COUNTY OF MIDDLESEX - INTERROGATORY #1

Filed: May 23, 2013
EB-2013-0040 and EB-2013-0041
Exhibit B
Tab 1
Schedule 3
Responses to County of
Middlesex Interrogatories
Appendix A

APPENDIX 'A'

Filed: May 23, 2013
EB-2013-0040 and EB-2013-0041
Exhibit B
Tab 1
Schedule 3
Responses to County of
Middlesex Interrogatories
Appendix B

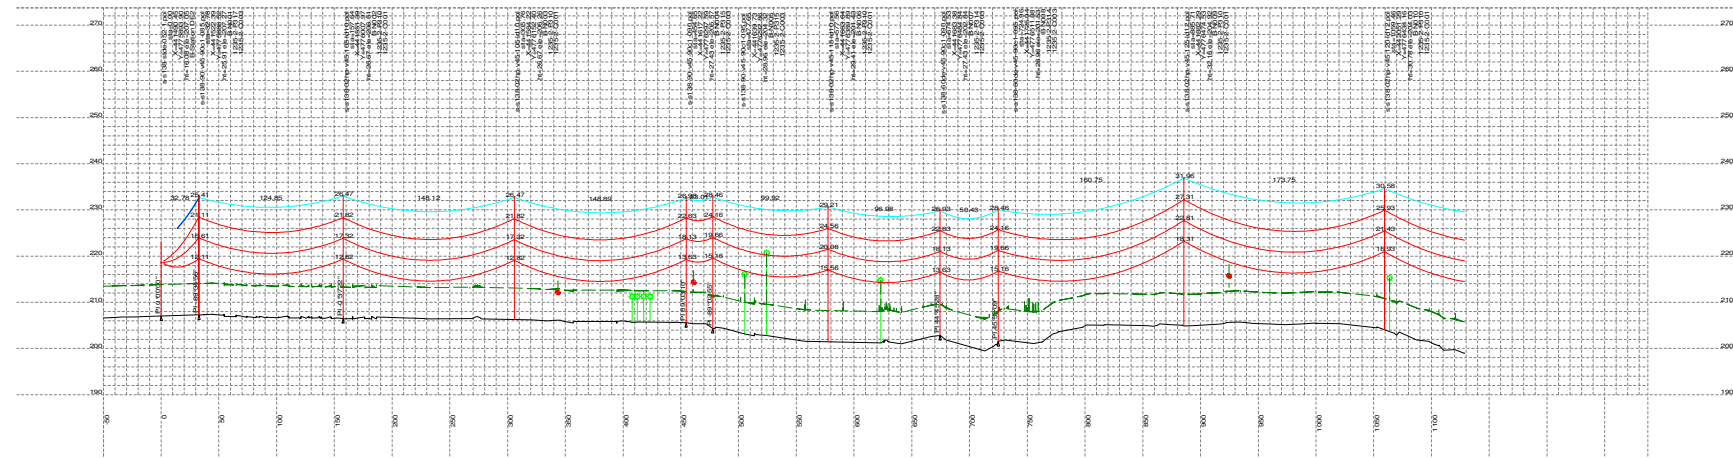
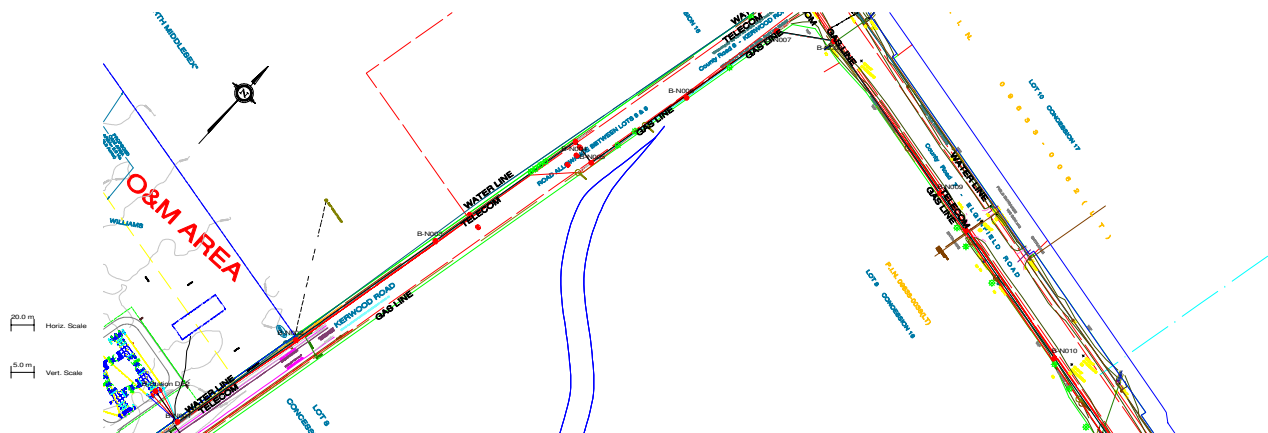
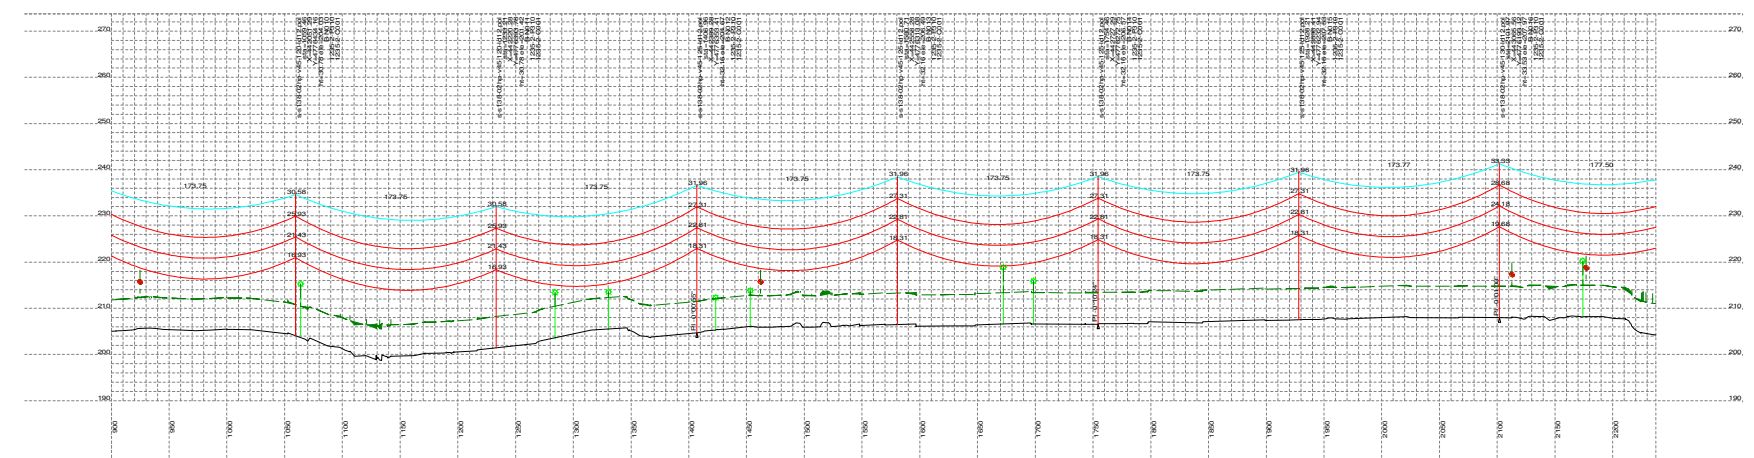
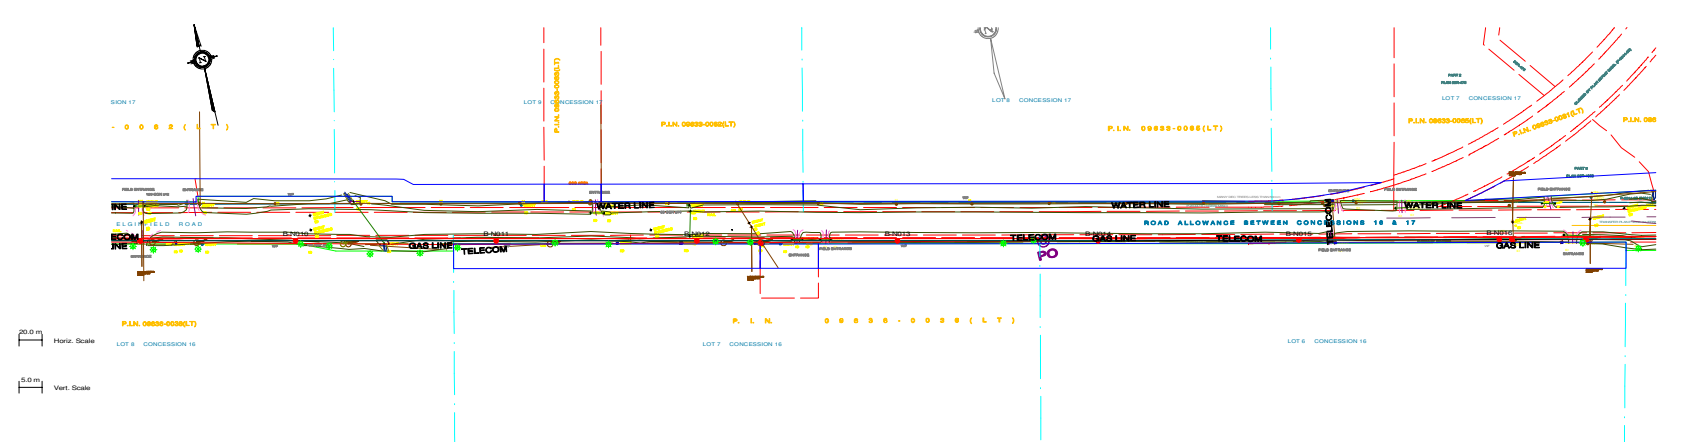
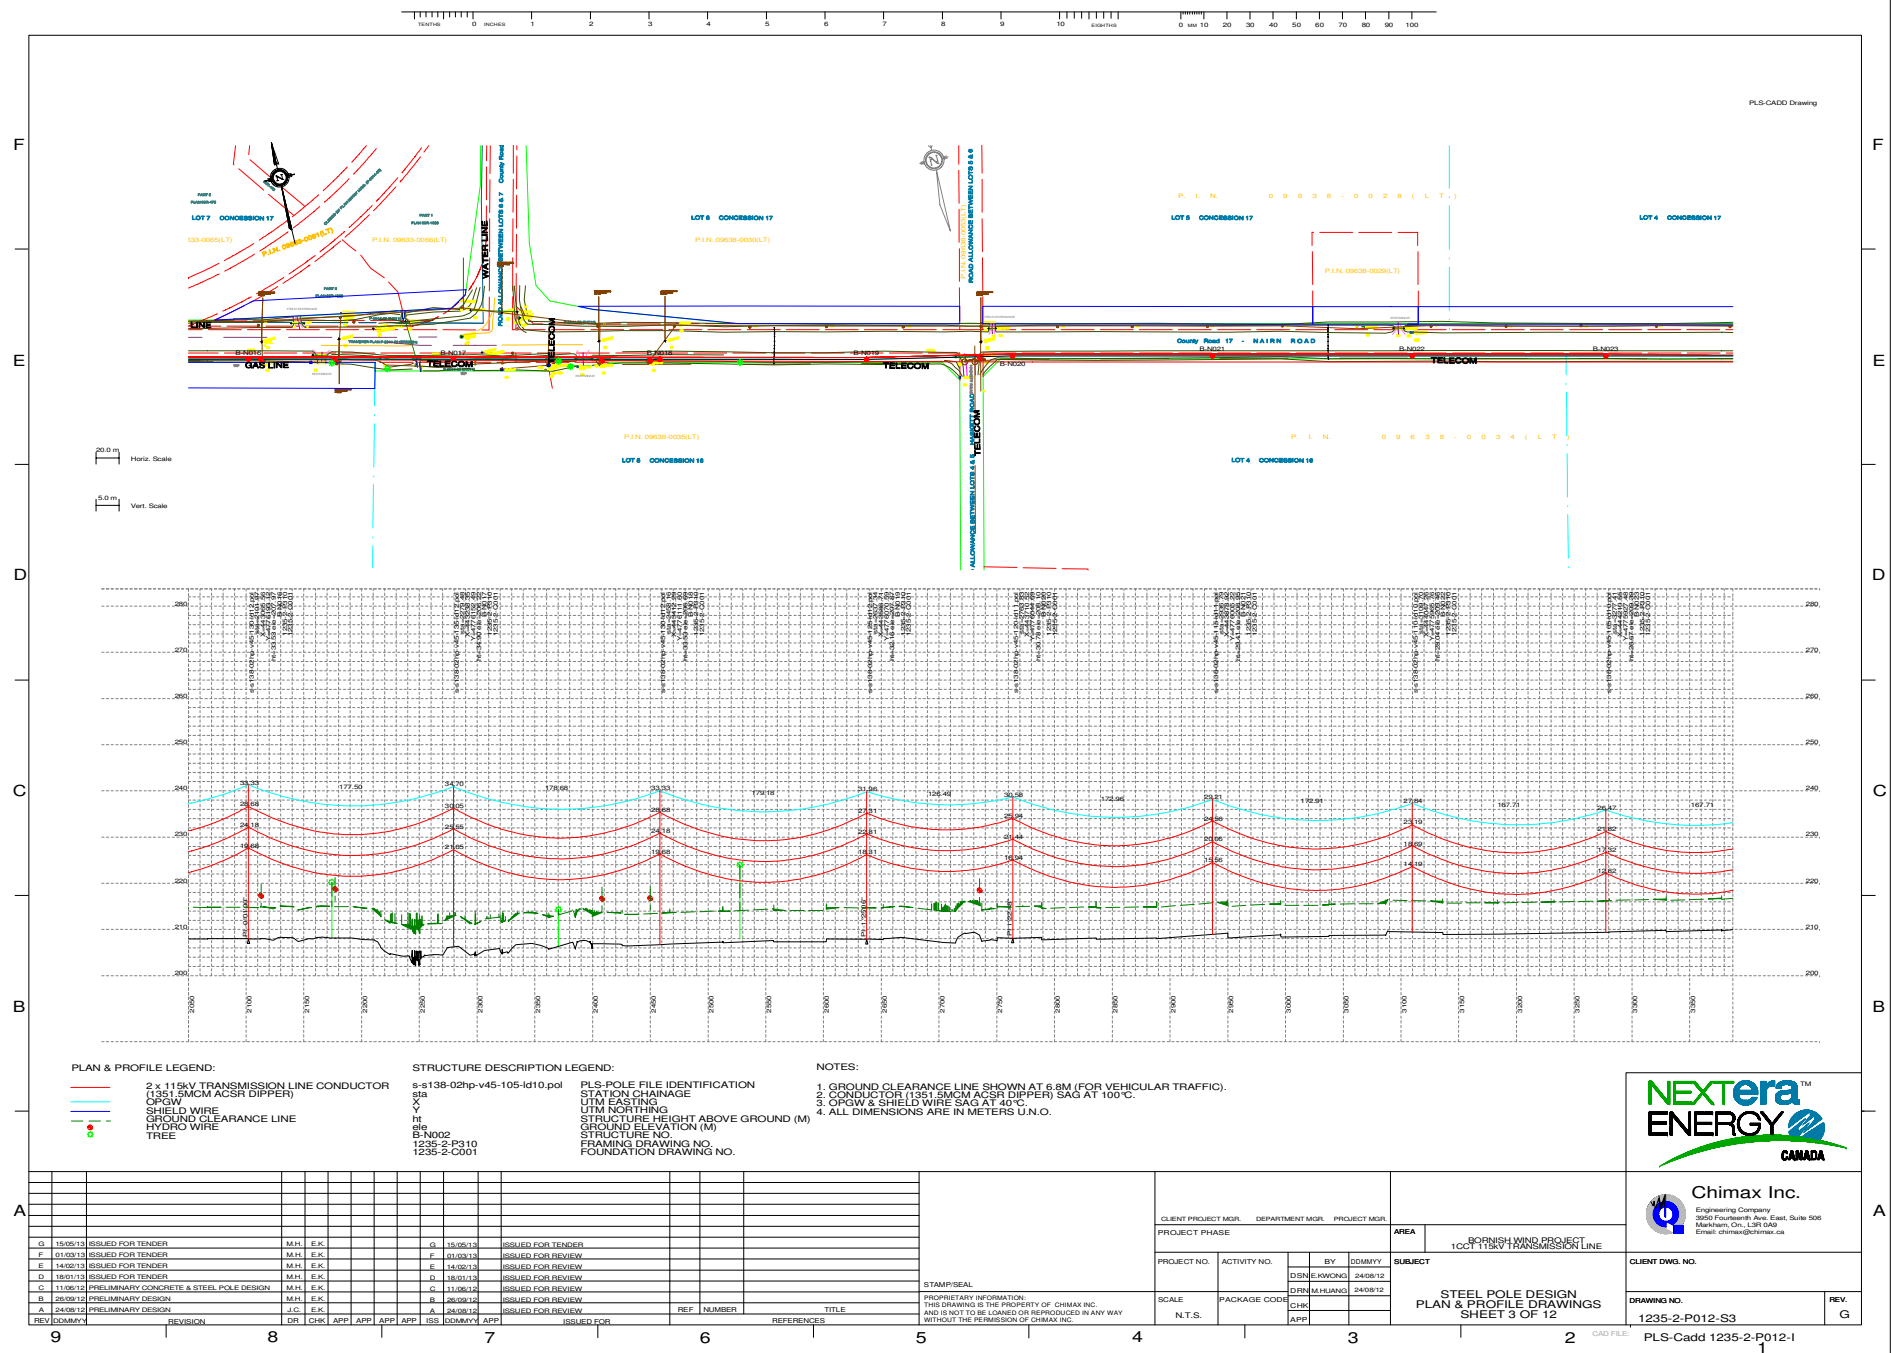
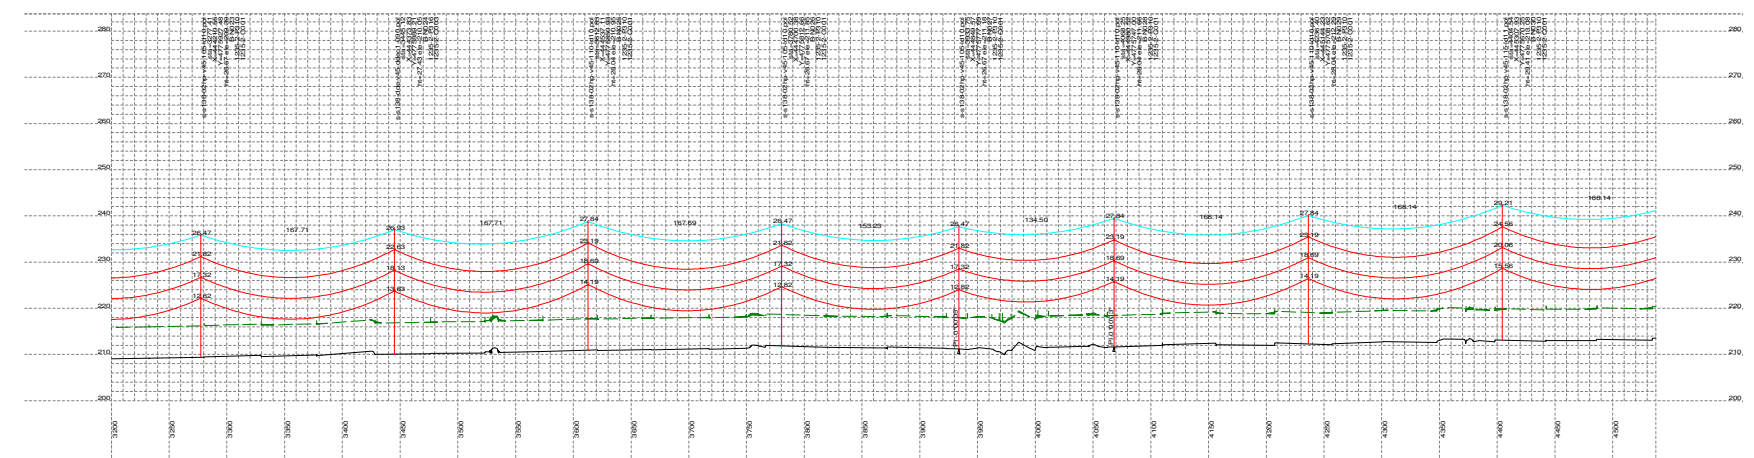
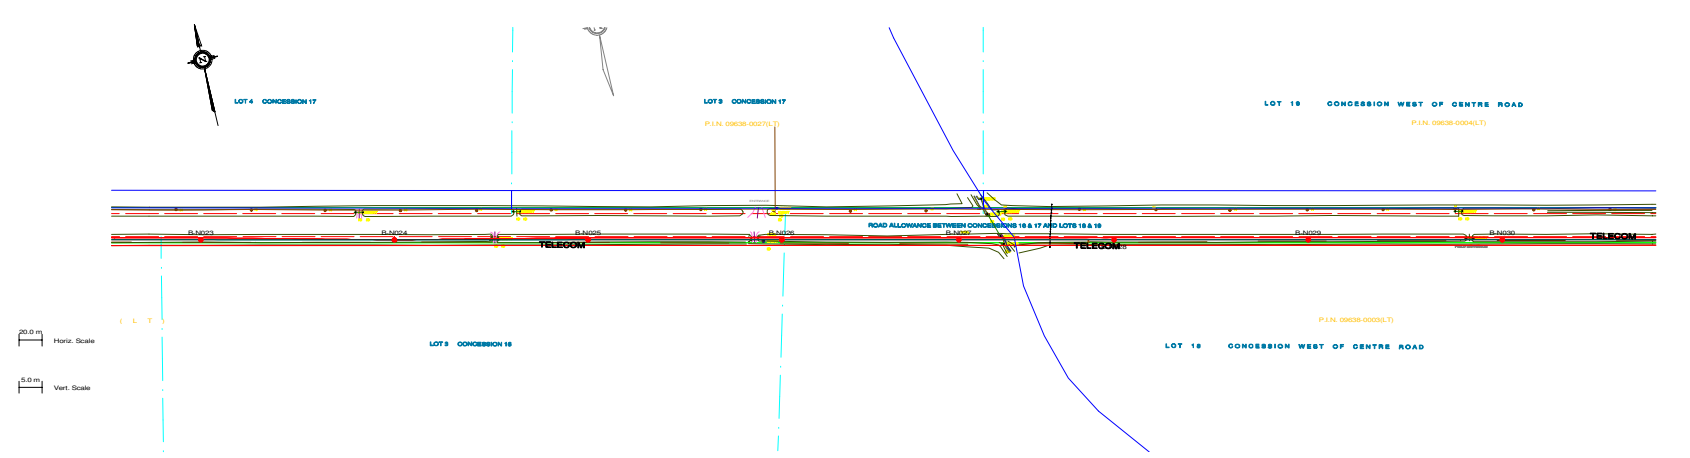
Please provide detailed engineering drawings showing the exact location of all poles and other appurtenances proposed to be located within County road allowances for transmission lines, including all material and construction specifications of poles, wires, guying, foundations, trenching, temporary conditions, and any other items related to this infrastructure.

Please see profile drawings in **Appendix 'A'** in respect of EB-2013-0040 and **Appendix 'B'** in respect of EB-2013-0041 depicting the current design, which is subject to final engineering. Earlier versions of these sets of drawings were provided to the County's Engineer on November 12, 2012. These drawings show the proposed pole, wire and anchor locations. Plans with respect to foundations, materials and construction specifications are not yet finalized. The physical design specifications for the proposed transmission line, including with respect to potential materials, are described in Exhibit D, Tab 1, Schedule 1. In addition, illustrations of potential pole structures and framing designs are provided in Figure 4 of Exhibit B, Tab 2, Schedule 5.
